Re: FortisBC Energy Inc. (FEI)

Annual Review for 2023 Delivery Rates (Application)

Response to the Residential Consumer Intervener Association (RCIA) Information Request (IR) No. 1

Provincial Rate Per Thousand Locates

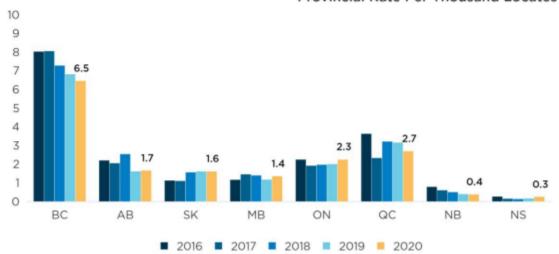
8.1 Provide the average number of line damages per 1,000 line locate requests for other Canadian gas utilities as aggregated and averaged by the Canadian Gas Association.

FEI does not have specific information to explain the difference in the results between provinces. However, factors and practices that can influence line damage results include: the province's legislation around licensing and punitive damages for the offender; the role of the technical regulator and its regulations around excavators and excavation; and the effectiveness of damage prevention awareness programs like the BC One Call program. These factors make it difficult for a meaningful comparison of the results between provinces.
